DATE June 10, 1996	JOB NO. 96-3251
ATTENTION Mr. Bill Jeffers	
RE: Burkhardt Crossing

*Supplement  
to  
Final Drainage Report  
for:  
Burkhardt Crossing*

**RE: BURKHARDT CROSSING  
SUPPLEMENT TO FINAL DRAINAGE REPORT  
OUR PROJECT NO. 96-3251-4**

## BURKHARDT CROSSING DRAINAGE PLAN

F.E.S. OUTLET DETAIL (Parallel with swale flow)

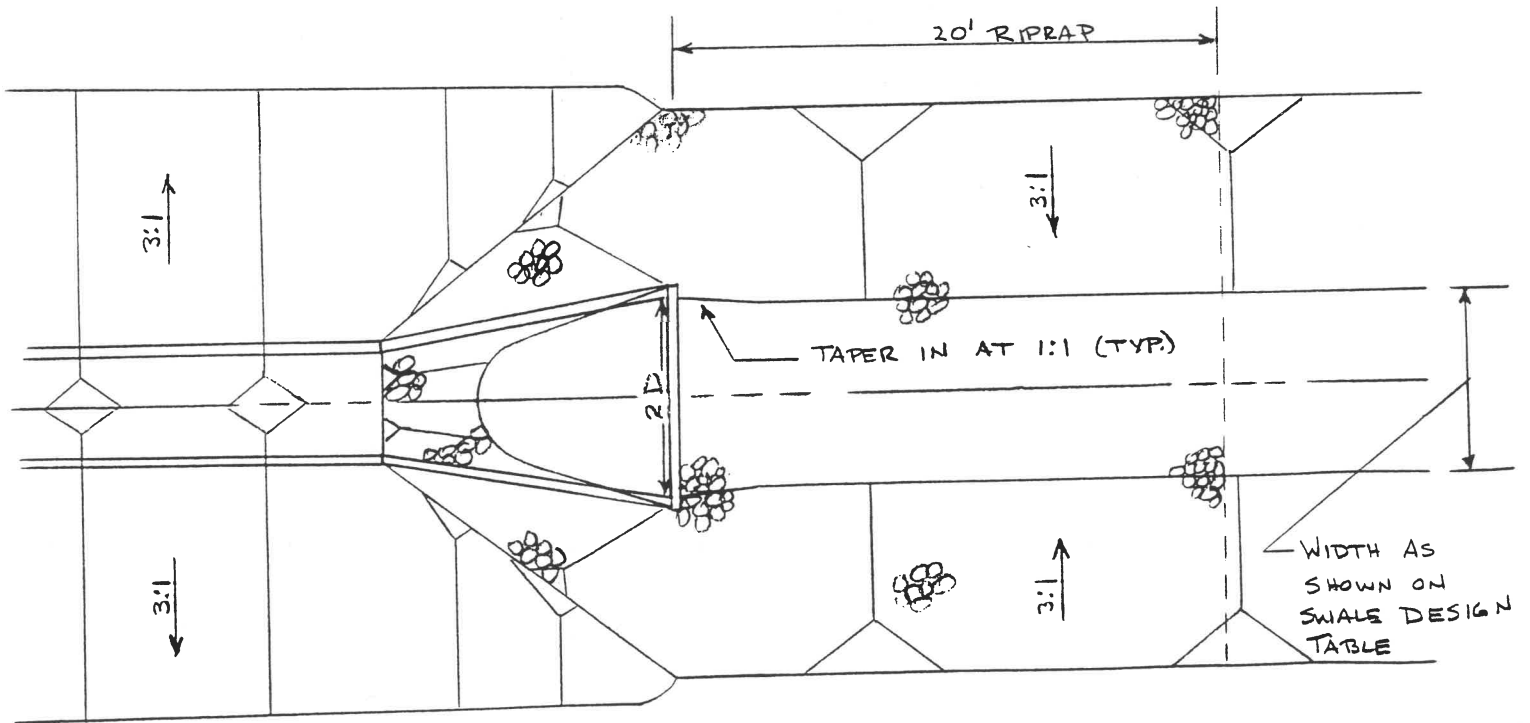
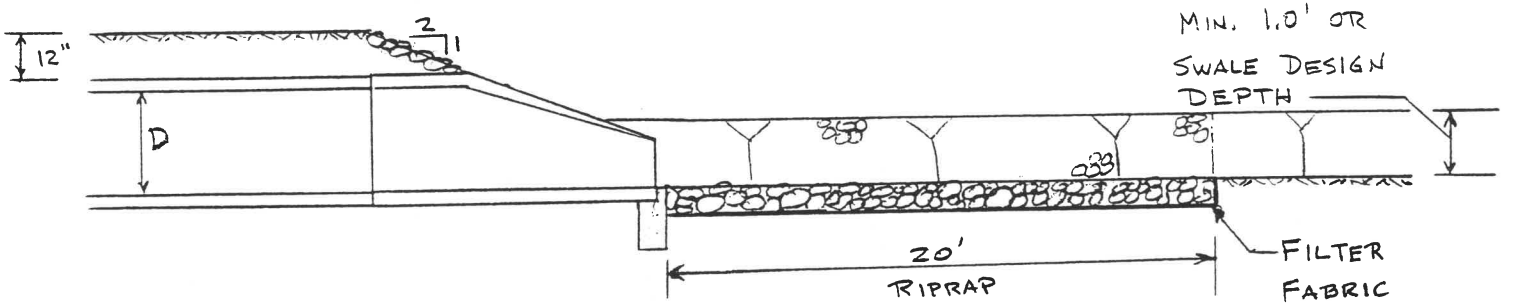
- A. We need a minimum 25' wide path atop a cross pipe at this location.
- B. Give exact details of pipe and headwall.
- C. Give exact details of rip rap apron: consider gabion blanket.

- A. Detail installation with headwall.
- B. Details of rip rap. Consider gabion mat.

- A. The outlets on Structure Numbers 1036 and 1036A will have flared end sections with riprap aprons. No flapgates are planned for these outlets, so headwalls are not necessary.
- B. Details of the riprap at the outlets of the pipes are included. The plan view of the riprap aprons shown on the drainage plan is drawn to scale and accurately represents the size and extent of them.

Enclosed is a copy of the Storm Details drawing which includes details on the concrete FES structures to be used. Typical details of the riprap mats/aprons are enclosed.

F.E.S. OUTLET DETAIL (PERPENDICULAR TO SWALE FLOW)

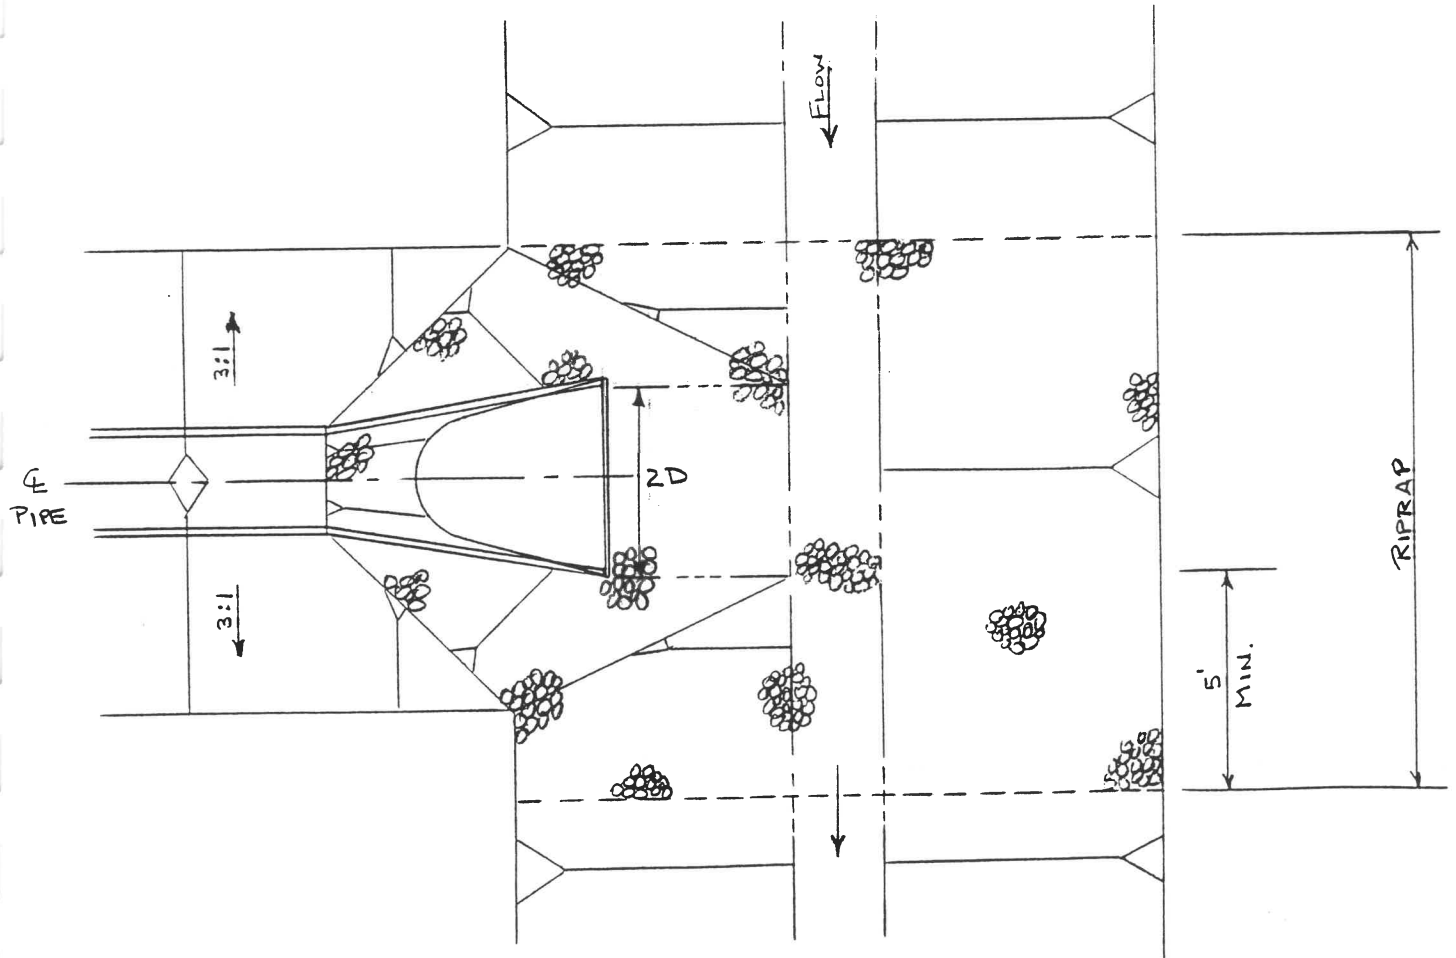
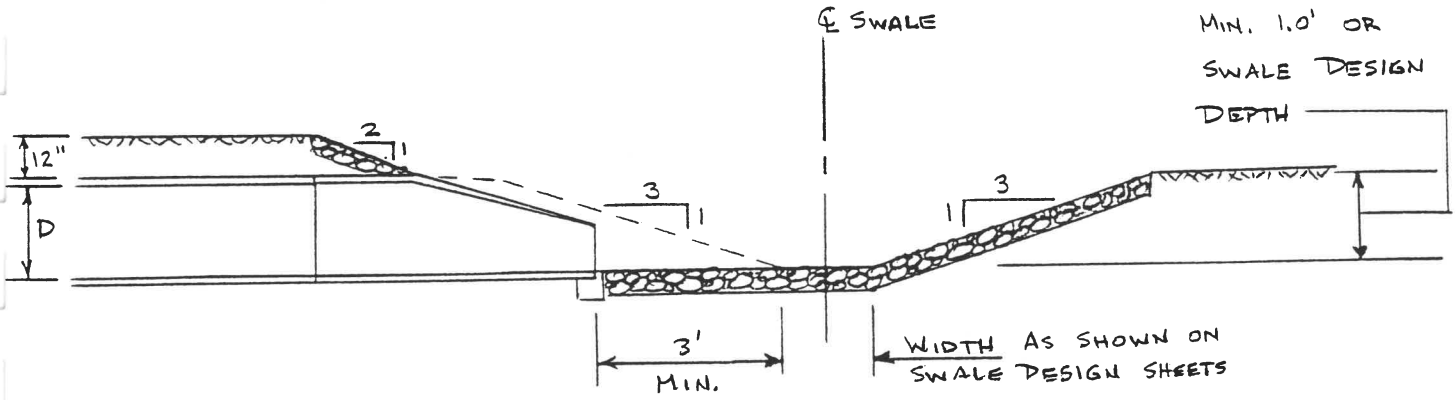
XV. DETAILS OF FES STRUCTURES: INVERTS, SIZES, MATERIAL, RIP RAP MATS, ETC. (THEY'RE NOT IN THE TABLE)

The invert elevations for all FES structures are shown on the drainage plan. The I.E.'s for FES structures 1000 and 1006 were added to the drawing; all other FES inverts were previously shown.
